Temporary Site Plan Approval and Approval of Waivers, Re: Space Coast Daily Park Fairgrounds (23SP00006)  
Applicant: Giles Malone (District 4)

Application Number: **23SP00006**  
Application Name: **Space Coast Daily Park Fairgrounds**

**RE: Review Comments**

**C-2**

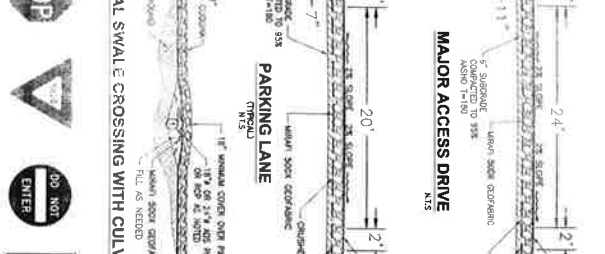
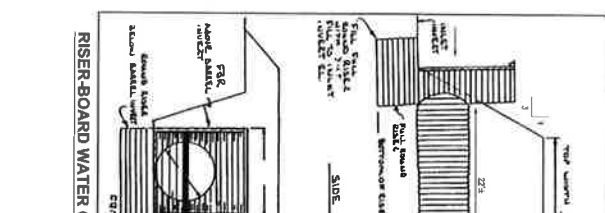
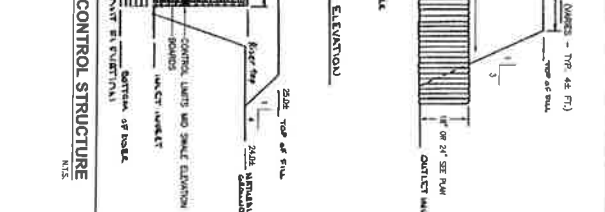
- iii. On Sheets C-1 and C-2: Please clarify the proposed “Riser-Board Water Control Structure” detail. Include dimensions and elevations (elevations of control structure should be specific and not varies). Are the two (2) swales (trenches) running east-west being used for stormwater treatment and attenuation? Please label the swale top of bank and toe of slope elevations and include cross-sections (elevations of control structure should be specific and not varies). Please include swale stage/storage information in the stormwater calculations.
